NOTICE TO ALL FIRMS

Re: Addendum Number 1
IFB # C1558 – East Courtyard & Pomerantz Center Air Handler Units Replacement

From M-011.00

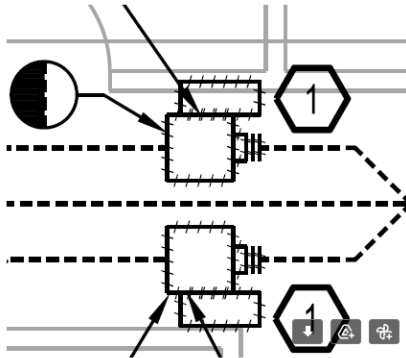
- Q6. Looking the following drawings and notes associated with those drawings, AWL is looking for clarification. Per drawing M-011.00 the note states “. . . contractor to remove the existing Johnson Controls and replace it with new Distech VAV controller.” The drawing itself notes that the entire VAV to be demolished. Per drawing M-101.00 note #1 states “Replace existing VAV controller with new VAV controller”, and the drawing depicts a new VAV box to be installed. We are looking for clarification that the drawing M-011.00 show that the VAV to remain and the controller be demolished rather than the entire VAV as currently shown. See photo below.

- A6. The scope of work is to remove and replace only the VAV controller and the space temperature sensor associated with each VAV. The VAV box will remain.
- Q7. As per contract drawing M-105 Note # 2, steel dunnage for new AHU's is under separate contract (roofing Contractor) and we need to coordinate with roofing contractor installation of new units. Please confirm that all steel as per this note, as well steel indicated on "A" drawings are under separate contract, not under this contract.
- A7. The steel dunnage is provided under a separate contract. However, this contractor is required to review the steel dunnage submittal and coordinate the AC unit fabrication and installation with the steel dunnage contractor. The AC unit submittal will not be released until the steel dunnage submittal is reviewed and accepted by this contractor.
